# Proposed Variation No. 1 of Kilkenny City & Environs Development Plan 2014-2020

Chief Executive's Report  
on Submissions received

**Kilkenny County Council  
July 2015**

**Figure 3.4 Variation No. 1**

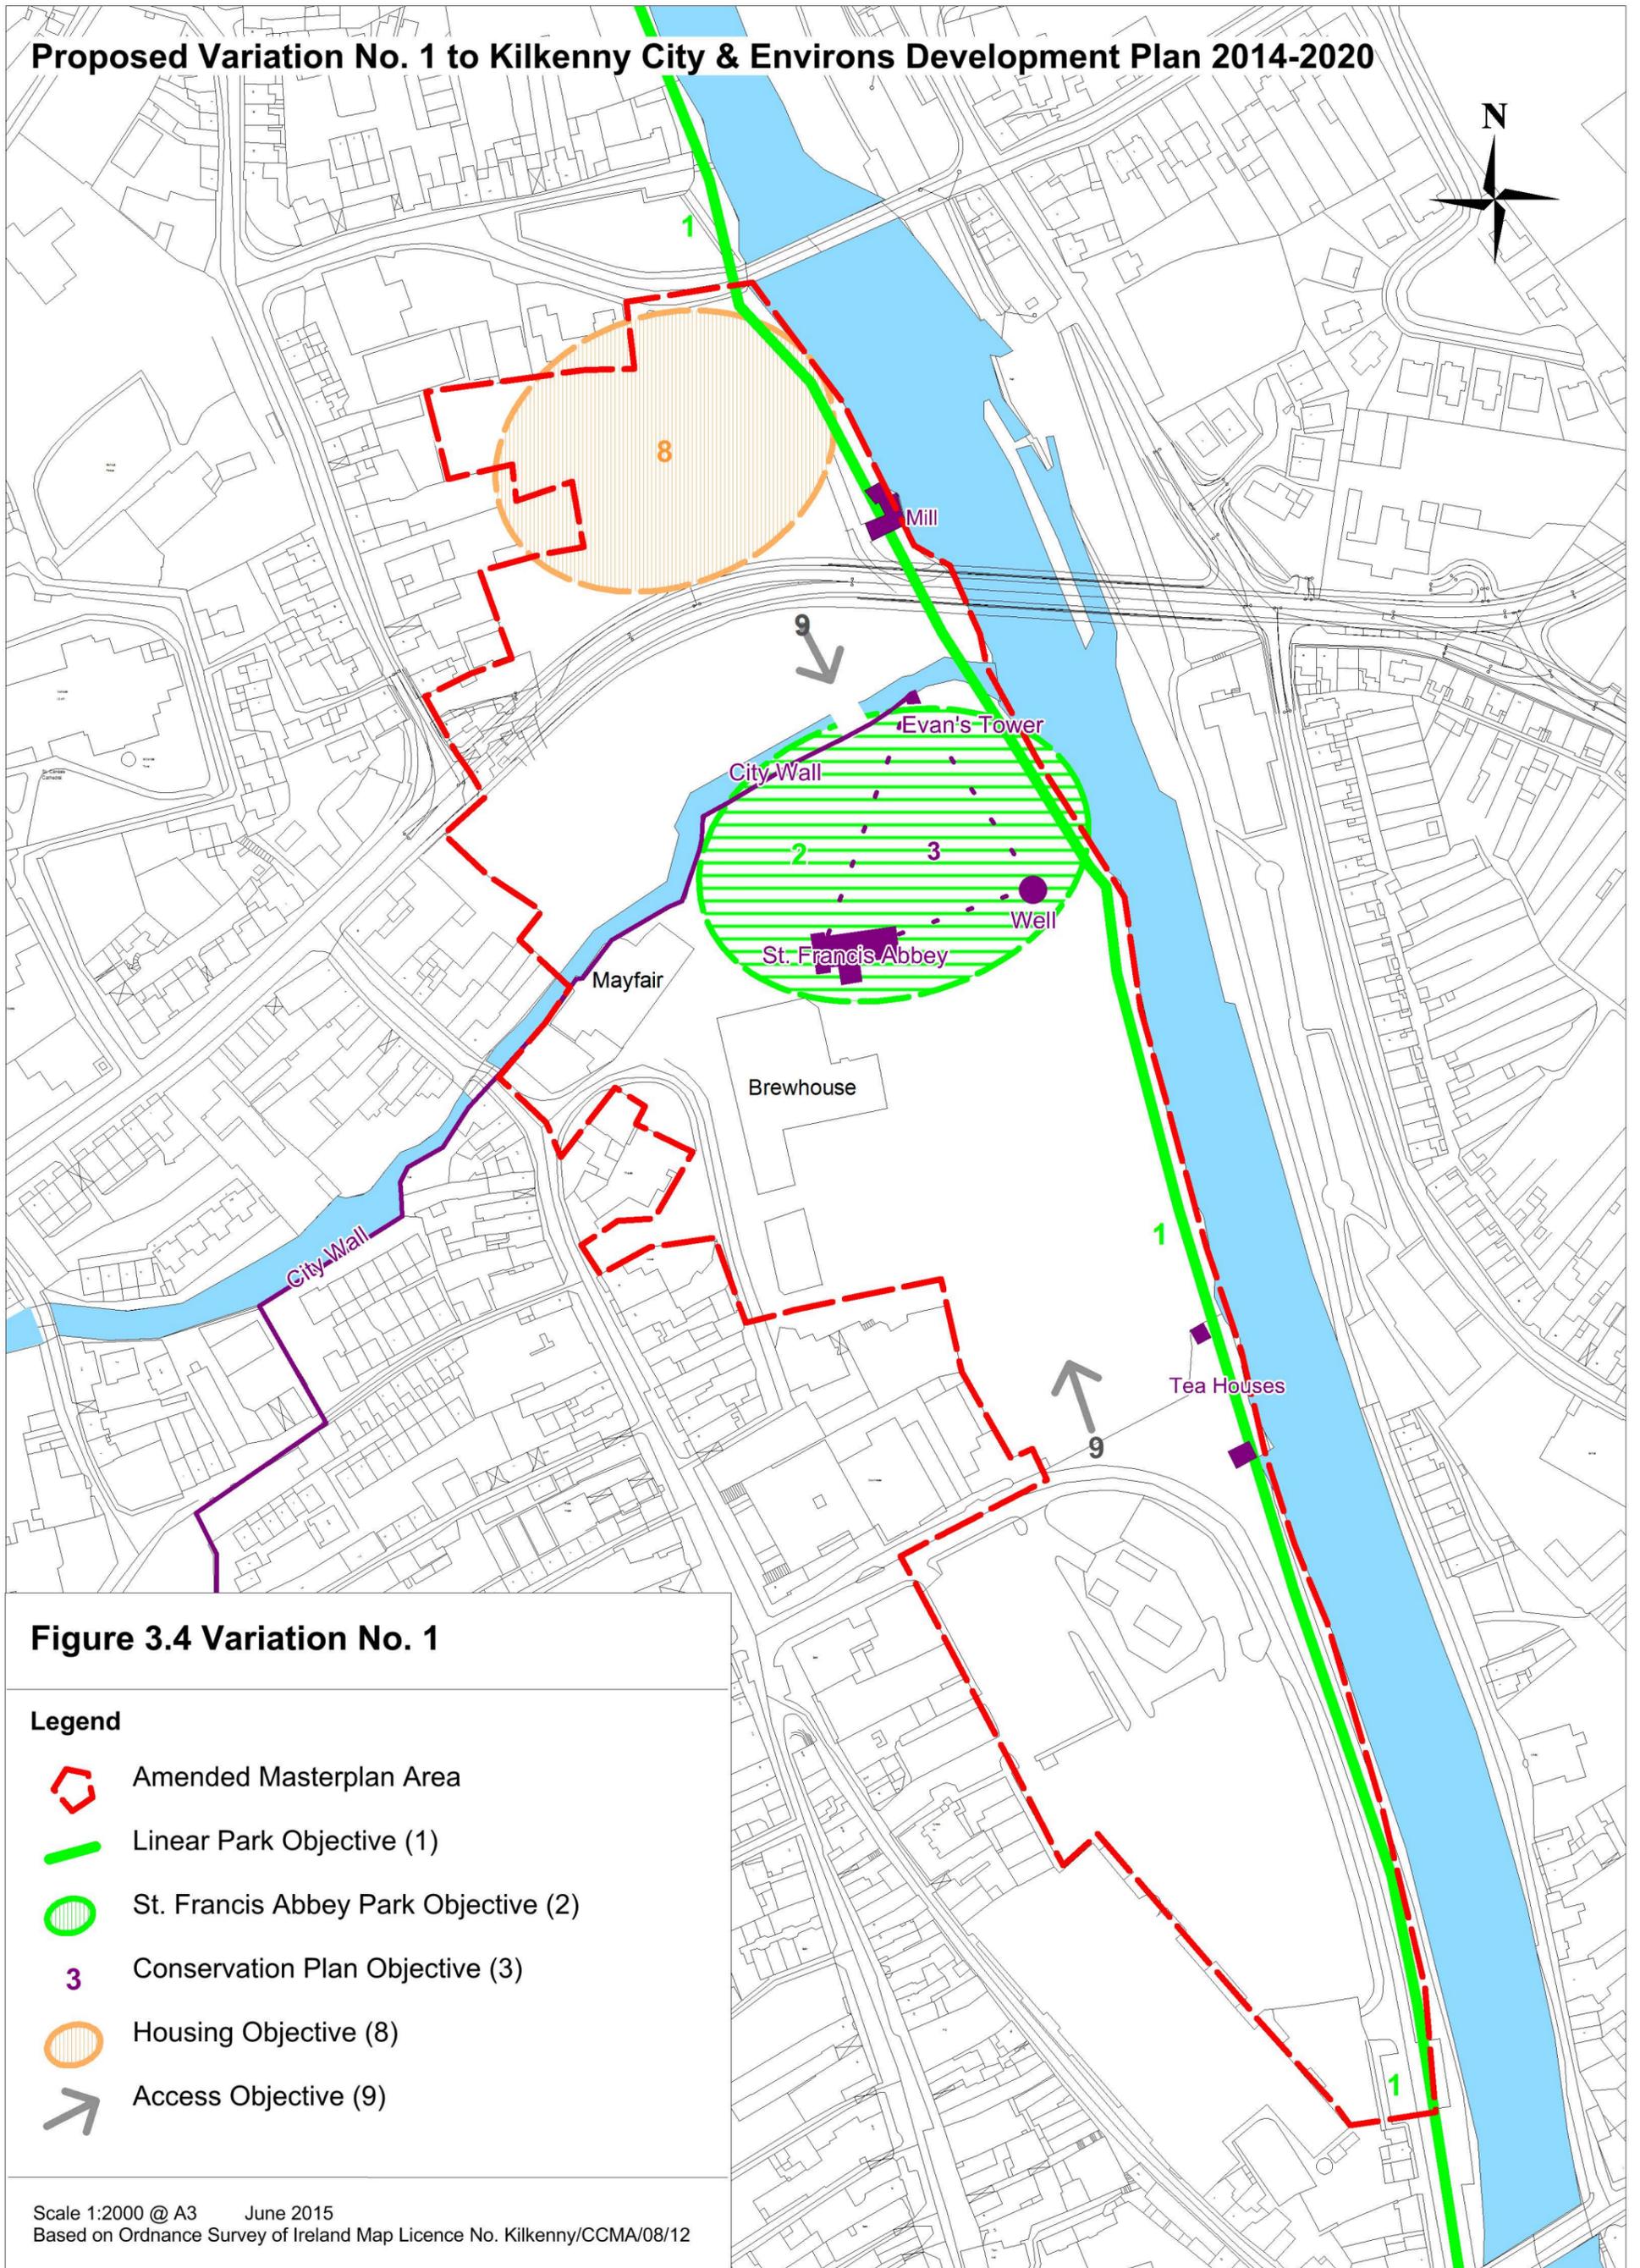
Ref	Name	Summary
V2	<b>Department of Arts, Heritage &amp; Gaeltacht</b>	<b>Archaeology</b> <ol style="list-style-type: none"> <li>1. An underwater archaeological strategy should be addressed in any future revision to the overall archaeology Strategy to be contained in the Abbey Quarter Masterplan.</li> <li>2. The archaeological heritage of the Masterplan area relates to both upstanding/above ground structures and buried archaeological remains. It is imperative to mention this in Section 4.9.3 of the Environmental report.</li> <li>3. New views to and from National Monuments and significant historical sites and landmarks within the City will potentially be opened up and the protection and enhancement of this intervisibility should be a critical element of any landscape assessment.</li> </ol>

<ol style="list-style-type: none"> <li>4. Objective 1 should include compliance with the archaeological strategy, including any underwater archaeology strategy, to be developed as part of the overall Masterplan.</li> <li>5. Objective 2 should also mention the inclusion of the associated city defences (city walls) in the urban park and the consideration of alternative approaches to interpretation and presentation of the historical structures and further archaeological remains discovered during the archaeological excavations in advance of the design of such an urban park.</li> <li>6. Objective 3: The Local Authority has stated in the SEA scoping document relating to the proposed Development Plan Variation No. 1 that there will be consultations with the Department of Arts, Heritage and the Gaeltacht and the Office of Public Works (OPW) <i>“to get available details with respect to the long-term conservation and management of St. Francis Abbey in the context of the Framework Plan”</i> and these details will be included in the final Framework Plan. Section 6 of the Revised Archaeology Strategy states that <i>“as St Francis’ Abbey is in state care it is presumed that conservation will be undertaken by the authorities as necessary.”</i> It is important that this matter be addressed in the final Framework Plan. The long-term conservation, interpretation and presentation of St. Francis Abbey and any additional masonry/archaeological remains uncovered during the proposed archaeological excavations within the Abbey precinct shall require a conservation and management plan in advance of any such works on site.</li> <li>7. The Local Authority needs to consider whether individual proposed developments within the Framework Plan area will be subject to Environmental Impact Assessment, as the redevelopment of this quarter could be characterised as an “urban development project”, as it is located within an urban landscape of “historical, cultural and archaeological significance” (see EIA Directive 2011/92/EU Annex II, 10 (b) and Annex III, 2(c)(viii) and successive 2014 legislation).</li> <li>8. Any archaeological strategy adopted as part of the final Framework Plan will need to outline a detailed step-by-step procedure to be followed by prospective individual developers/applicants and design teams when developing sites within the area. (The master plan area)</li> <li>9. Objective 5: It is imperative that the findings and recommendations of the archaeological strategy influence and inform the final design and development layout within the overall Framework Plan area. The Department of Arts, Heritage and the Gaeltacht has previously recommended and wishes to reiterate that the condition and load bearing capacity of the concrete slab will require assessment as will the nature and extent of archaeological remains surviving below the slab before any method of archaeological mitigation can be suggested and agreed with the relevant authorities. It cannot be assumed that the retention of the concrete slab and piling construction methods is the optimum solution until detailed and site specific archaeological assessments are carried out on each development site within the Framework Plan area.</li> <li>10. Apply appropriate archaeological assessment and mitigation to objectives 6, 7 &amp; 8 of the variation.</li> </ol>

<p>11. The Department is concerned regarding any potential visual impact the proposed ramped access from the Central Access Scheme (CAS) to the Framework Plan area may have on the setting and amenity of the adjacent National Monuments (St Francis Abbey and City Defences, Evans Tower) and the nearby St. Canice's Cathedral and ecclesiastical site. This matter should be addressed in any landscape assessment carried out as part of the Framework Plan. Details regarding any required Part 8 applications or other permissions should be provided in the final Framework Plan</p> <p>12. In the consideration of alternative scenarios regarding access for the Masterplan/Framework area, it has been noted that development options will be examined including for transport. It is important that the various options for proposed access points (i.e. road access, emergency access, pedestrian access, bridge, etc.) be archaeologically assessed to ensure that the access points and proposed roadways/streets within the Framework Plan area are positioned, designed and constructed to ensure the preservation and protection of both the amenity and physical remains (both above and below ground) associated with the National Monuments located within the Plan area.</p> <p><b>Nature Conservation</b></p> <p>13. This proposed variation is to allow for the proposed Masterplan for the Abbey Creative Quarter. The SEA is therefore similar to that for the proposed Masterplan and the natural heritage comments of this Department are therefore the same as outlined below. However while a NIR was produced for the proposed Masterplan only an appropriate assessment (AA) screening was carried out for the proposed variation.</p> <p>14. While overall the SEA is comprehensive with respect to the natural heritage it has unfortunately been restricted to looking at designated sites within a 15km radius, which is a rule of thumb often used for Plans but is not suitable for rivers, where a whole catchment may need to be included.</p> <p>15. The indicator for B1 in the SEA has been restricted to the article 17 reports of this Department which does not include birds. In addition objective B3 has only included compliance with the Wildlife Acts 1976-2010 with regard to the protection of species in schedule 5. This means that birds and plants have been omitted. All wild birds are protected under the Wildlife Acts and protected plants are listed in SI 274 of 1987.</p> <p>16. The SEA refers to a habitat survey which indicates the habitats to be impacted are "River Nore" and "grassy banks". The photographs in the Masterplan appear to indicate that some of the river is bounded by wall but that some still has riverbank vegetation. Such vegetated areas are important refuges for biodiversity and may be used by otters. Prior to any final design for the linear park, which is part of the proposed Variation 1, an ecological survey / ecological impact assessment (EclA), will be necessary to ensure no negative impacts on the ecological corridor or species such as otter and kingfisher, listed on the annexes of the Habitats and Birds Directives respectively.</p>

Ref	Name	Summary
V5	Darragh Byrne	<ol style="list-style-type: none"> <li>1. The Masterplan and Variation processes should be separate. By integrating the masterplan into the Variation the process is flawed.</li> <li>2. The second reason for the Variation (funding and resource opportunities) is flawed as current funding, in particular from ISIF, has been falsely portrayed as time sensitive.</li> <li>3. The linear park should be 15m wider to facilitate wildlife.</li> <li>4. The Urban Park in Objective 2 should be larger to accommodate archaeological excavation around the Abbey. The demolition of the Mayfair and part of the Brewhouse would open up views of St. Canice's, the City Wall and St. Francis Abbey.</li> <li>5. The 'urban design criteria and archaeological recommendations' in proposed objective 4 are vague. There's no assurance that unsightly large scale office would not be built there.</li> <li>6. Objects to the proposed objective no. 5 as finalizing and adopting the Masterplan without signing off on the variations first makes a nonsense of all planning. The masterplan would then be binding from a statutory point of view.</li> <li>7. Objective 6 seems agreeable.</li> <li>8. Objective 7: A bus park is unsuited to the area. If another brewery built here then a bus park would be reasonable. Provision for smart cars and a bus scheme should be installed.</li> <li>9. Objective 8 is premature if cheaper and better housing can be provided elsewhere in the city. The area to the north of CAS could become a ghetto and unsafe with motorway traffic.</li> <li>10. Object to a road through the site as per proposed objection no. 9.</li> <li>11. The consultation process has been bogus. The Masterplan and Variation processes should be delayed until after the summer break as it is premature. The masterplan should be decided first and then the Variation.</li> <li>12. An exhaustive and complete archaeological report should be carried out; Re-instatement in the masterplan of 'medieval character of the streetscape'; No large road through the site; No office block; no car parks; 15-30m of wildlife between river and linear park; include a skatepark.</li> <li>13. There should be a new Variation to demolish the Mayfair and the Brewhouse which obscures St. Francis Abbey from being excavated.</li> </ol>

Ref	Name	Summary
V9	Gladys Bowles	<ol style="list-style-type: none"> <li>1. Partook in all workshops on the Brewery Revisioning, and was delighted to do so; and made submissions to the Masterplan – now believes this has been a waste of time. The people who took the time and effort to attend and submit have been ignored in the content of the proposed Variation No 1 – therefore strongly objects to the proposed variation.</li> <li>2. Entire variation is premature as the Abbey Creative Quarter Masterplan is (a) incomplete, (b) has not yet been adopted and (c) does not reflect the outcome of the public consultation process.</li> <li>3. Objective No1: (a) linear park is too small - it should be at least 30m wide, (b) objective should specifically include, in words, the retention of the wild habitat, extending the length of at least the line of the Poplar trees, and the bank from the river back up to the Poplar trees, and the trees themselves as a protected wild habitat.</li> <li>4. Objective No 2: Need a full archaeological excavation and survey of the entire site before the master plan is put out for adoption. All proposed planning and development must be generated by the results of a comprehensive and open archaeological on-site survey that has not yet happened; therefore this objective is flawed and premature.</li> <li>5. Re: Urban Park in the vicinity of the St. Francis Abbey - everything is subject consultations, and these consultation conclusions have been ignored. Why?</li> <li>6. Re: Urban design - unless a full Archaeological excavation commences, a preparation plan cannot determine what should be envisioned on the site. Please do the Excavation.</li> <li>7. The re-visioning document produced by the planning department states "The proposed Variation to the City and Environs Development plan will not commence until the Masterplan for the area has been finalised and approved by elected members of Kilkenny County Council". This has not been done!</li> <li>8. Re: A low carbon energy strategy for the Masterplan area - object to any plans being made before a full Archaeological (dig) excavation should be done first as a priority to determine what should be allowed on the site.</li> <li>9. Re: Parking for Cars, Bus/coach - object strongly to the provision anywhere near the Abbey Creative Quarter. At the consultations, parking of any kind in or around the Abbey Creative Quarter was strongly opposed.</li> <li>10. Welcome any form of housing, but have strong reservations on the location, between two bridges. Entrance should be from Greens bridge and from Vicar Street, with houses realigned to reflect this, this would assist with integration into an already existing community. This specific site is ideal for the setting of the Micro brewery which was proposed in the last round of submissions by two different companies (Costello's and O'Hara's) as this area is not part of the Diageo site but in close proximity to the site.</li> <li>11. Under no circumstances should any road (spur road) should be run from the</li> </ol>

Ref	Name	Summary
V11	Cllr. Malcolm Noonan	<p>1. Amend Objective 6 to read: To develop a Zero Carbon Energy Strategy for the Masterplan Area and advance the provision of Zero Energy and passivhaus standard buildings on site. All renewable energy generated on site shall be managed by Kilkenny County Council using and Energy Supply Company (ESCO) model. The site shall be designated a Sustainable Energy Zone within the City and Environs Plan and revenues accrued from energy generation shall be ring fenced for community projects within the City</p> <p>2. Remove Objective 7 and replace with: To pursue park and ride/park and stride opportunities off site and sites in close proximity to the Abbey Quarter Masterplan site but outside of the Architectural Conservation Areas (ACA's) and to advance plans for a 3 vehicle electric shuttle bus for service for the City to serve tourism and local commuter needs.</p> <p>3. Amend Objective 8 to read: To provide for housing: private, social/ local authority and cooperative within the Masterplan in suitable location based on Urban Design Principles and way form point sources of vehicle pollution and noise and the areas of the site that offer highest capacity for quality of life for residents</p> <p>4. Remove Objective 9 and replace with: To make the site subject to a 'Smarter Travel' Plan where pedestrian and cycle access and the provision of public transport infrastructure are prioritised over private car travel, to improve quality of life and to help the City meet emissions reduction set down by the EU. Local access road infrastructure will accommodate deliveries, residential, business and other activities. The site shall not be connected to the Kilkenny Central Access Scheme (KCAS) due to potential adverse impacts on traffic and mobility and distortion of the traffic projections envisaged in the parent approved scheme. Pedestrian and cycle access will link towards linear and provide routes to schools and work for residents</p> <p>5. Add Objective 10: Provision shall be made for the detailed suitable location and design of an all weather public skate park on the main master plan site and not adjacent to or under CAS Bridge.</p>

<p><b>Response</b></p> <p>1. An underwater archaeological strategy will be devised as necessary and in response to the design and development proposals. The present framework report is a live document and as information becomes available it can be incorporated and responded to. To date the report details the historical importance and significance of the River Nore and Breagagh, how they contribute to the setting of the masterplan area and archaeological investigations that have taken place to date. Once information in relation to the detailed design is available and the impact to the underwater archaeological resource is fully understood, a strategy response will be designed and will form part of Objective 4 'To prepare an urban design and recommendations and archaeological recommendations for the implementation of the Abbey Creative Quarter Masterplan'.</p> <p>2. Noted This will be mentioned. <b>Recommendation:</b> Refer to both upstanding/above ground structures and buried archaeological remains in Section 4.9.3 of the Environmental report.</p> <p>3. The redevelopment of the masterplan area provides an opportunity for an integrated multi-disciplinary approach to improve the presentation, legibility and civic amenity of these monuments. Central to this process has been the need to protect and enhance the inter-visibility of cultural heritage assets where possible and to achieve a balance between the urban design process, growth of this historic city, quality of life and conservation values. A number of these views have already been identified in the masterplan and as the urban design guidance regard will be had to this intervisibility.</p> <p>4. Objective 1 will comply with the archaeological strategy to be developed. <b>Recommendation</b> Include a sentence to this effect in section 4.2.3 at the end of the second last bullet point as follows: Works associated with the development of the linear park will comply with the archaeological strategy.</p> <p>5. Agreed. <b>Recommendation:</b> Include reference to City walls in Objective 2.</p>

11. The visual impact of the proposed access onto the CAS for the proposed urban street will be assessed during the detailed design process and at planning consent stage. Part 8 documentation has not been prepared for the access from the CAS to the proposed urban street.

4. The proposed urban street is not required or intended to supplement traffic capacity on the Central Access Scheme. As with all urban areas, the masterplan area needs a network of streets to provide permeability and connectivity and ease of movement.

5. Access to the plan area is needed to facilitate service and emergency vehicular access to the site itself and for non-vehicular amenity and tourist access. It will be pedestrian and cyclist priority. It will not be a through route for vehicular traffic.

2. The provision of any park and walk facilities must take account of the Council’s current and future mobility management plans for the City. This is the appropriate vehicle for addressing the wider issues. It is recommended to add “taking into account the mobility management plan for the City”

To provide for an urban park in the vicinity of St. Francis Abbey (National Monument) incorporating the **City Walls**, Evan's Turret and St. Francis' Well taking into account the recommendations of the archaeological strategy developed in the preparation of the Abbey Creative Quarter Masterplan (as indicated on fig 3.4) and subject to compliance with the Habitats and Birds Directives and the provisions of the Abbey Creative Quarter Masterplan,
